**Re: In the Matter of PacifiCorp, dba Pacific Power, 2021 Integrated Resource Plan
(Docket No. LC 77)**

Sierra Club's Comments on Staff Report

**SIERRA CLUB’S COMMENTS ON STAFF REPORT
[PUBLIC VERSION]**

Figure 2. Figure 7.5 from PacifiCorp 2021 IRP Volume I

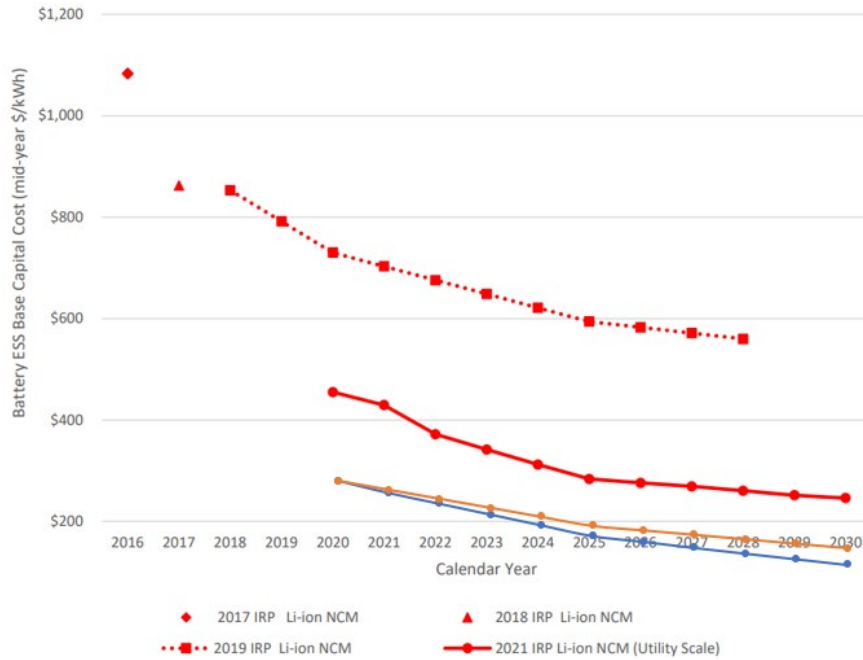
PacifiCorp should have considered longer duration batteries for a number of reasons. First, PacifiCorp noted in reply comments that “the storage component of proxy solar with storage resources in the portfolio was increased from 50 percent of the PV resource capacity to 100 percent of the PV resource capacity.”³³ This was an important step to obtain more reliability value from solar plus storage; however, it also suggests that increasing the battery size even further (e.g., to 150 percent or 200 percent) might yield even further reliability benefits. If connected as a DC-coupled resource, such an oversized storage system would in essence equate to a longer duration battery storage system that could better fit within PacifiCorp’s assumed interconnection limits. This would have been an appropriate step before moving to untested resource options. Second, although PacifiCorp has raised concerns over the cost of longer duration batteries, PacifiCorp’s storage cost assumptions were significantly higher than the National Renewable Energy Laboratory’s (“NREL”) Advanced Technology Baseline 2021 and further did not match the reality of actual project costs as informed by the recent all-source RFP bids.

The 2021 IRP’s Figure 7.5, in Volume I, (reproduced below) shows the forecast of storage costs that informed the Company’s modeling. In addition to the IRP’s cost curves, we have overlaid the NREL assumptions with an orange line (moderate) and a blue line (advanced).
